Subject: Updated Project Description Cover Letter - Compass Battery Energy Storage Project (Docket

Number 24-0PT-02)

Attachment(s): Section 2.0, Project Description

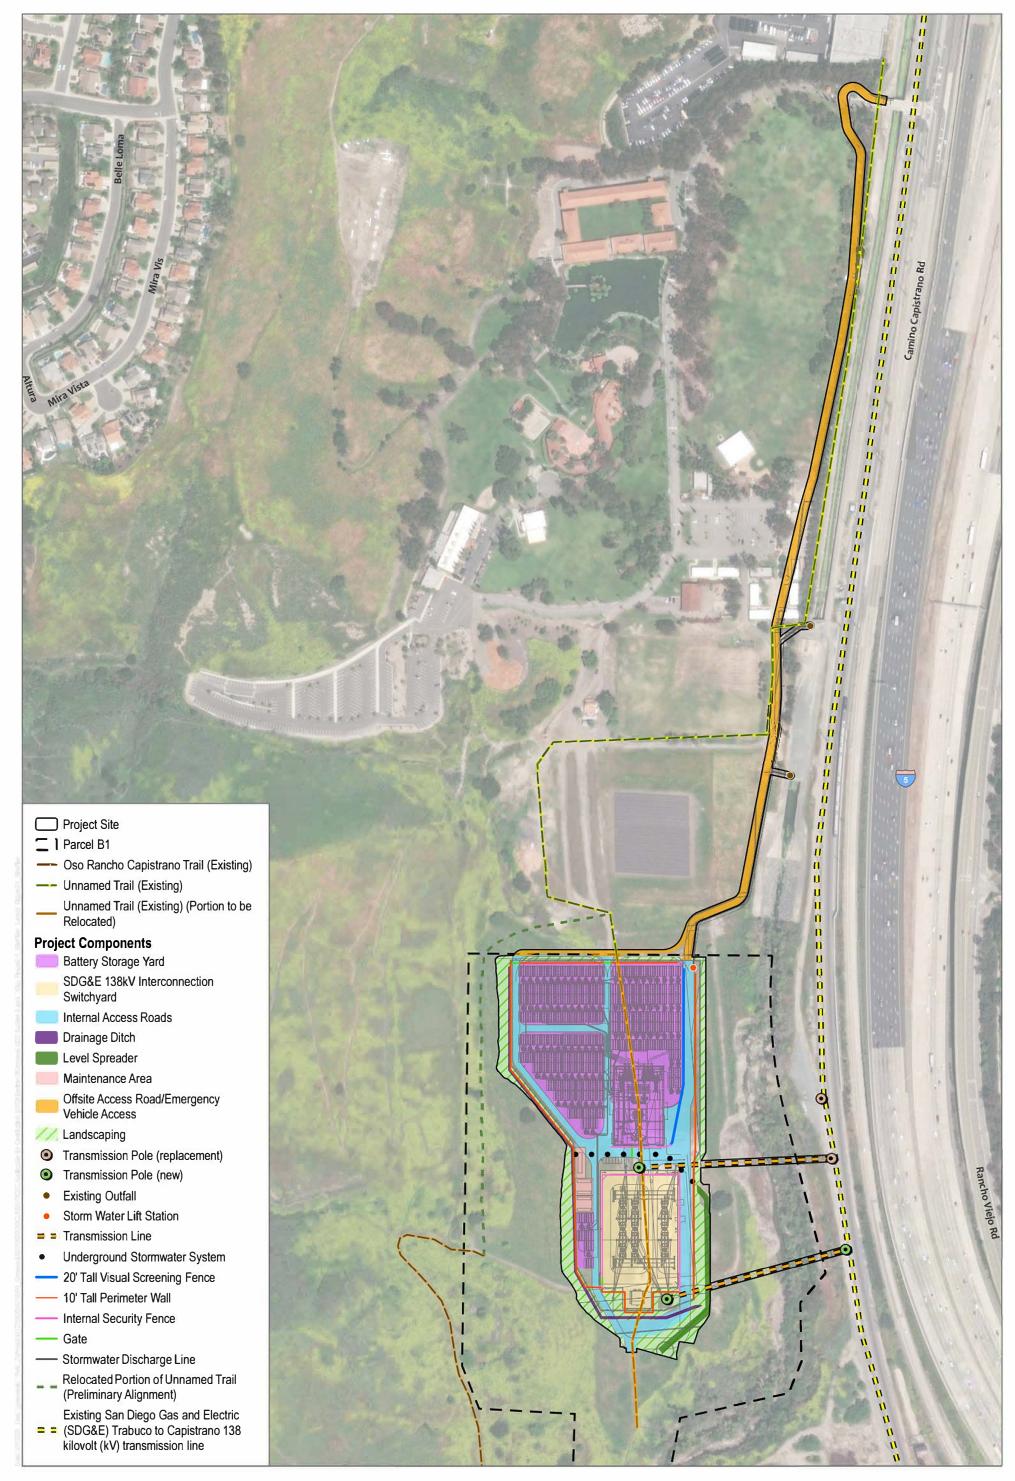
- Section 2.1, Overview and Location has been updated to reflect the revised acreage of the access road. Table 2-1, Preliminary Project Square Footage, has also been updated.
- Section 2.2.8, Site Access and Security has been updated to include a description of the additional entrances.
- A clarification has been added to Section 2.3.1, Schedule and Workforce.
- Grading quantities have been updated in Section 2.3.2, Site Grading and Earthwork.
- Please note, due to the nominal amount of additional acreage and grading for the additional access road
 and entrances (approximately 500 cubic yards), the estimated grading trips and amount of construction
 equipment necessary for grading will not change with the site plan updates. No updates to Table 2-3,
 Construction Scenario Assumptions are necessary.
- Figure 2-1, Site Plan has been updated.

Interstate-5 is the largest highway in the area and provides regional access to the Project site from the north and south. Access to the Project site will be provided via an existing access road off of Camino Capistrano approximately 0.6 miles northeast of the Project site. A new access road will be improved from the entry access road off Camino Capistrano along the east side of the property to the Project site. Road improvements shall consist of converting existing dirt roads into gravel roads and widening the roads to meet OCFA and SDG&E standards (30-feet wide). There will be three separate entrances/driveways into the BESS facility in accordance with OCFA standards. The three entrances/driveways will be located along the northern border of the BESS yard.
